City Of Taunton

Review of Proposed NPDES Permit Issues and Suggested Resolution of Scientific Uncertainties

February 18, 2015

“The Sentinel Method”

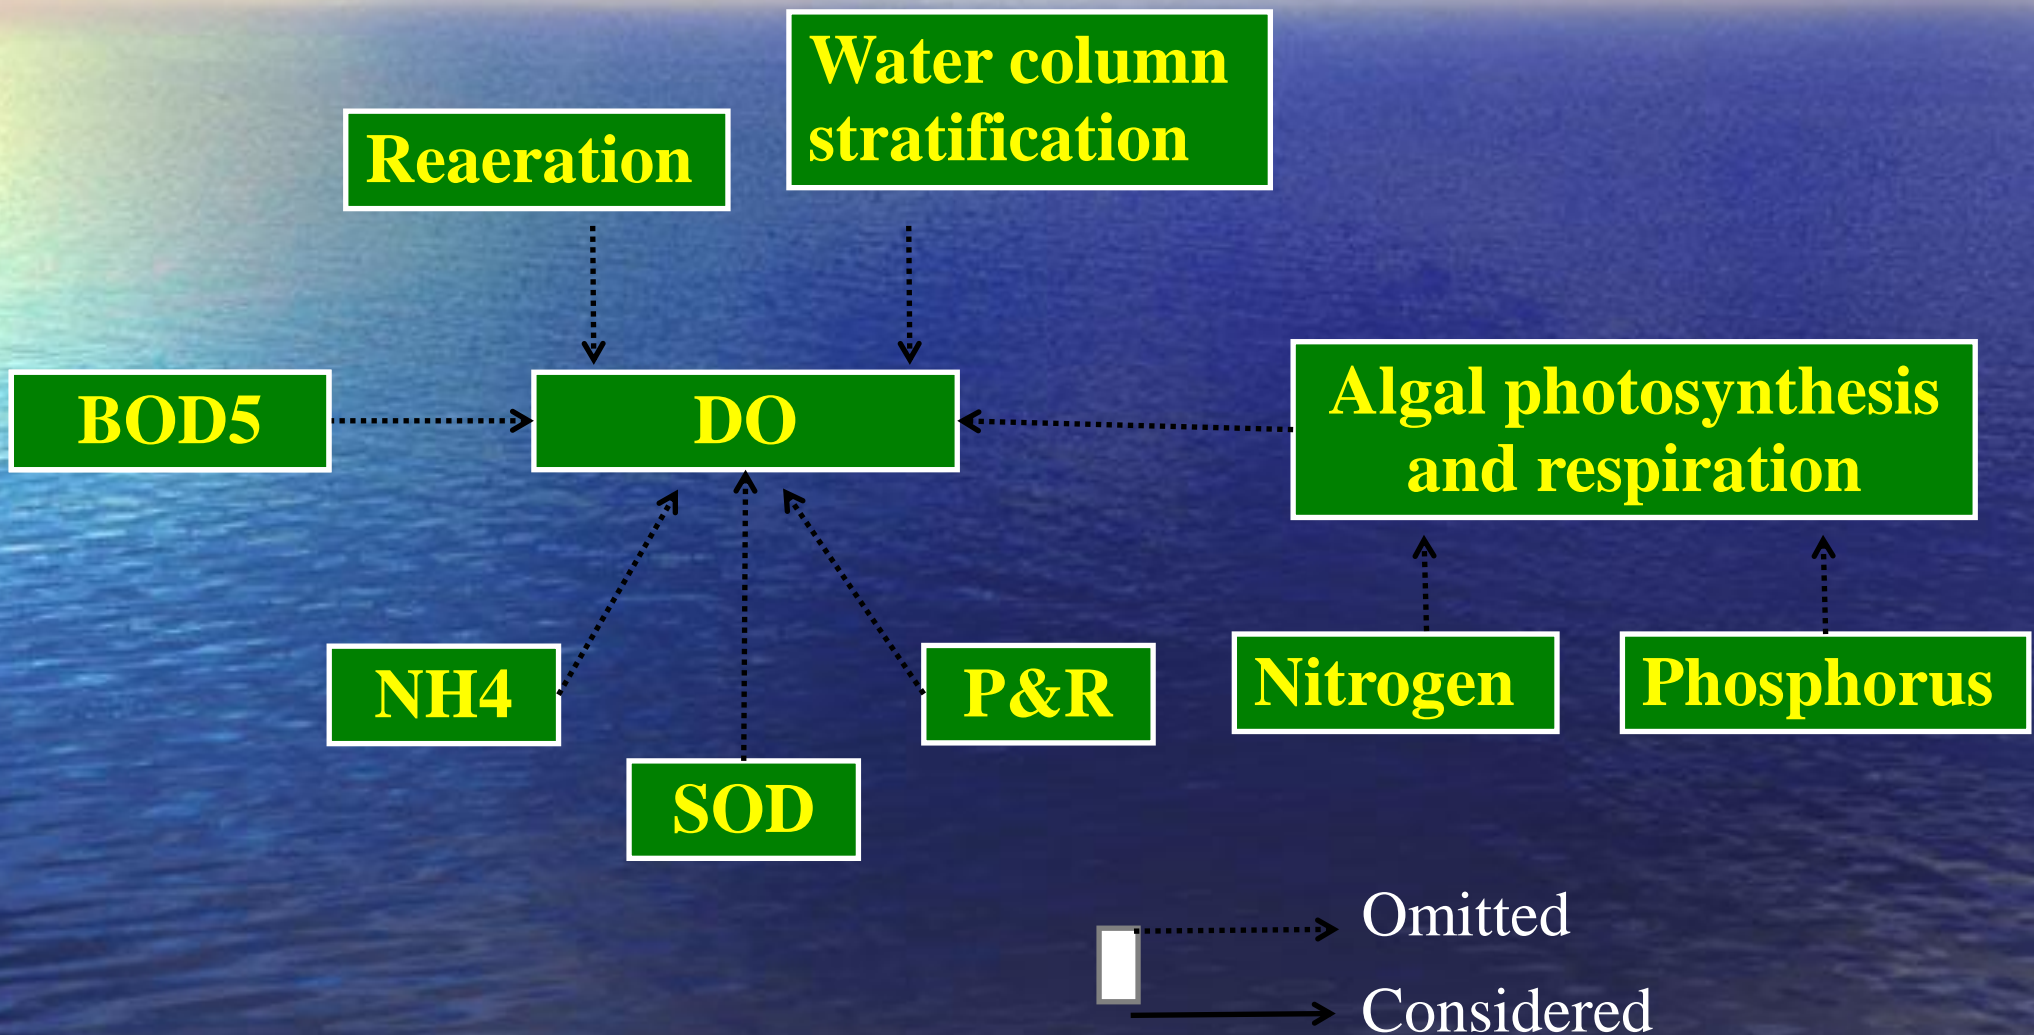
EPA determined DO standard met at MHB16 but not MHB19

EPA assumed TN at MHB16
required to meet DO WQS at
MHB19 (10 mi upstream)

No modeling or consideration
of hydrodynamic differences
